**LEGAL ADVERTISEMENT
HISTORIC PRESERVATION BOARD
CITY OF PORTLAND
Public comments are taken at all meetings.**

HISTORIC PRESERVATION BOARD AGENDA

**PUBLIC HEARING
104 WEST STREET**

**PUBLIC HEARING
197 SPRING STREET**

2 PROPOSED MIDDLE ST RENDERING
 0' 10' 20' NTS SCALE: NTS

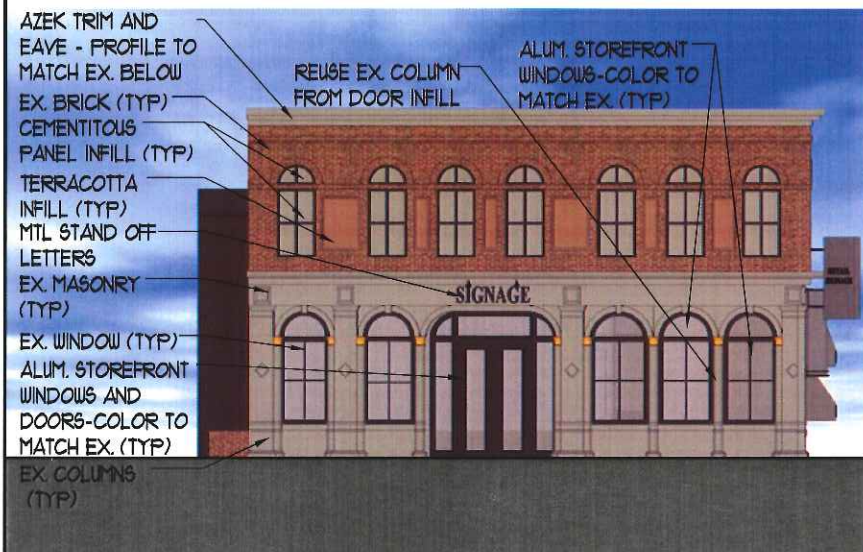
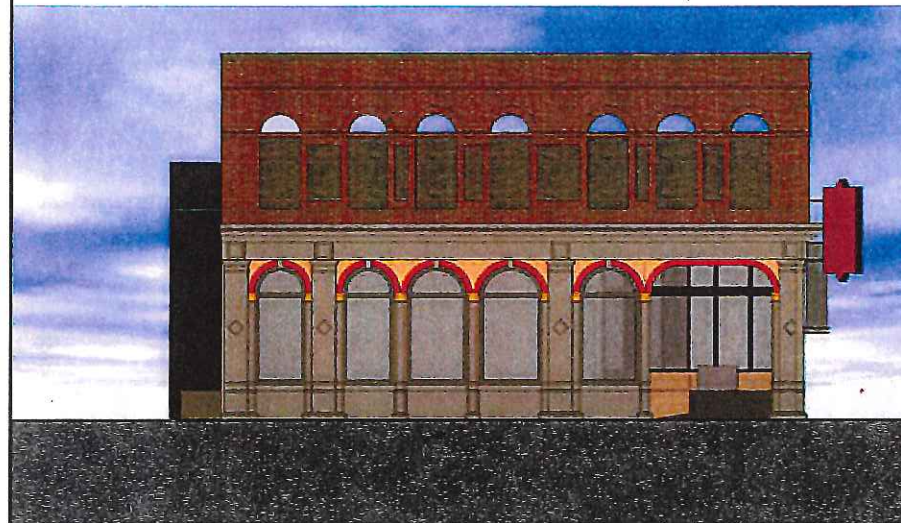
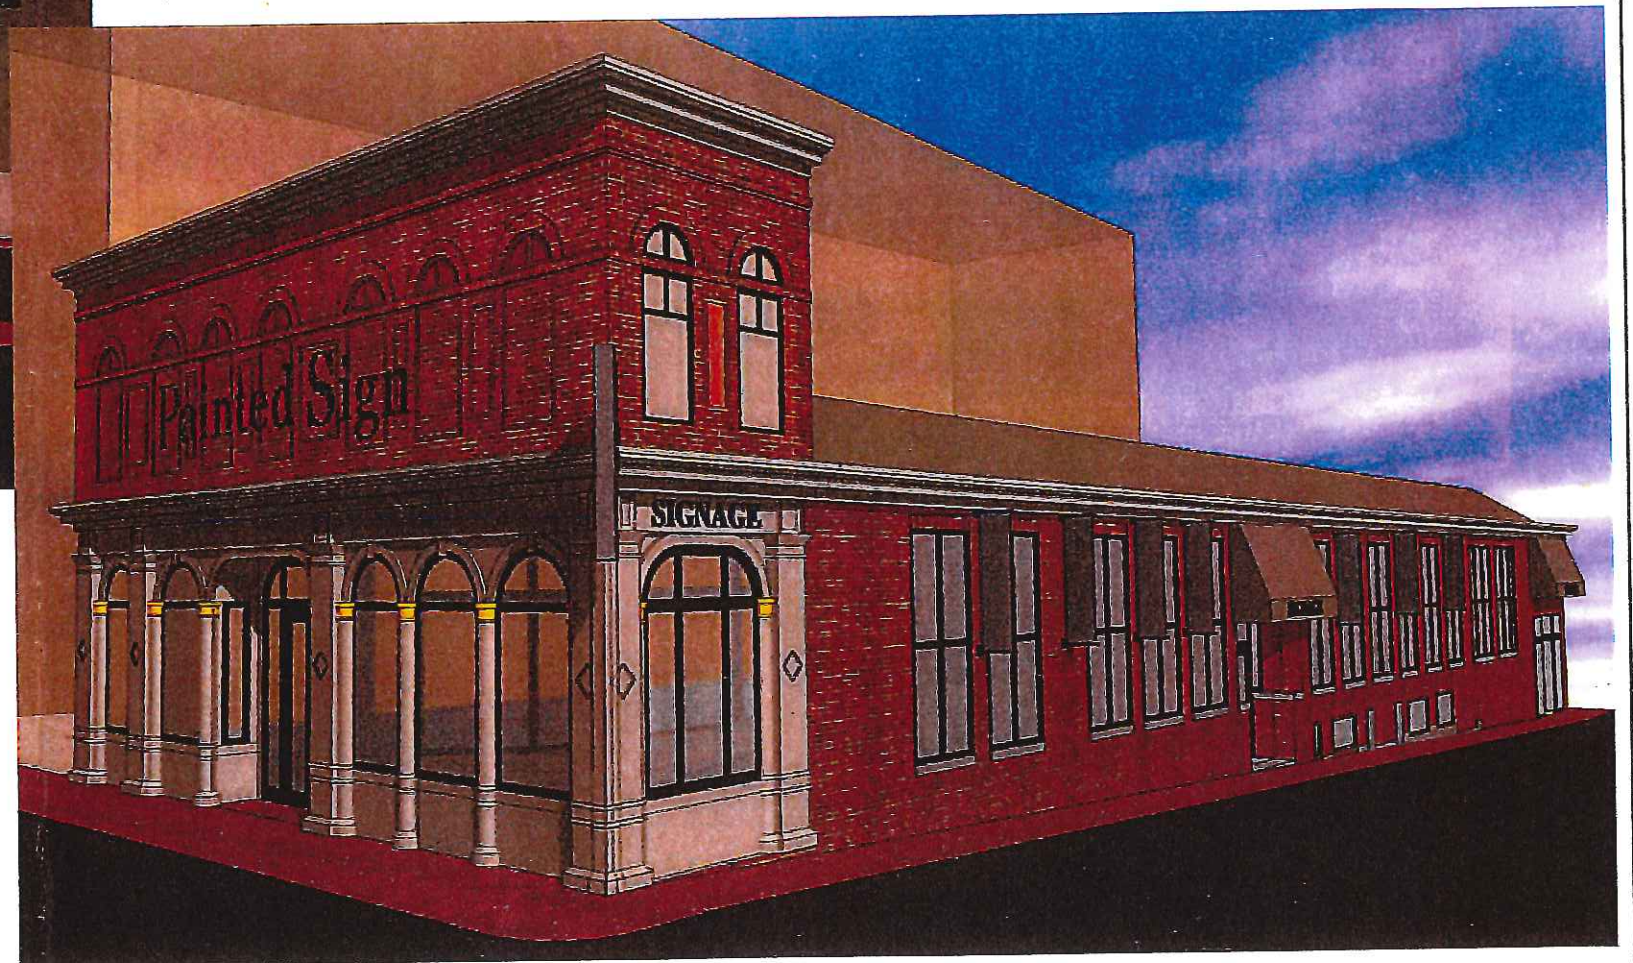
Staff is forwarding for the Board's feedback revised elevations and renderings by architect Andrew Hyland, submitted on behalf of NDA Middle, LLC. Mr. Hyland appeared before the Board on July 20, 2016 for a preliminary workshop. Hoping for further guidance on design direction, the architect submitted new draft elevations and renderings dated 7/22/16, showing revisions that responded to some of the Board's comments at the first preliminary review. As the revised submission was a late addition to the agenda, staff will merely introduce the images and the list of design changes provided by Mr. Hyland. (Because the next meeting of the Board is not until September 7, the applicant is hoping Board comments at the August meeting will make it possible to prepare for a public hearing in September.)

1. Removed painted signage
2. Added brick infill on Parapet
3. Provided a DAL tile for infill – Slimlite tiles
4. Added standoff letter signage (to be externally lit)
5. Indicated elevator clear overhead height
6. Lowered canopy @ lower Market St. entrance
7. Provided a Simplified Cornice
